e2 Environmental Ltd
PO Box 31159, Christchurch
www.e2environmental.com

15 June 2023

S92 RESPONSE BY MT COOK ALPINE SALMON LTD ON CRC233674 AND CRC233675 (ISAAC CONSERVATION TRUSTEES LIMITED)

Figure 6 Fish Screens Proposed at Intake (excluding debris screen)

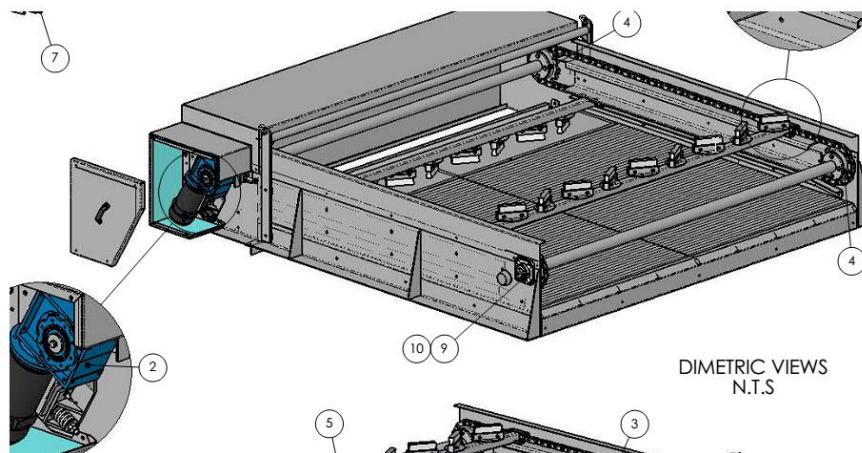
- b) Provide clarity on length of screens, and max take (rate) of water through each.

- d) Approach velocity calculations provided previously, will detail again with new dwg

A maximum of four pumps are proposed to be installed in the waterway, with the ability to take a combined maximum of 300 L/s. The design of the fish screen is such that one large fish screen will surround all three pumps, creating a large triangular area inaccessible to fish.

To comply with Schedule 2 of the Canterbury Land and Water Regional Plan (CLWRP), the fish screen must be at least 2.5 m² for an intake flow rate of 300 L/s. The engineering drawings dated 01/02/2023 depict a total of 4.72 m² of 3mm wedge wire screens surrounding the intake area (the updated drawings show slightly larger fish screens). Approach velocities for the fish screens cannot be calculated, and are recommended to be assessed when the screen installation is complete. The sweep velocities will be adjustable if required following installation. A combination of a large screen area, in combination with a diligent, and finally mechanised, brush-cleaning regime, is expected to minimise approach velocities to a level compliant with Schedule 2.
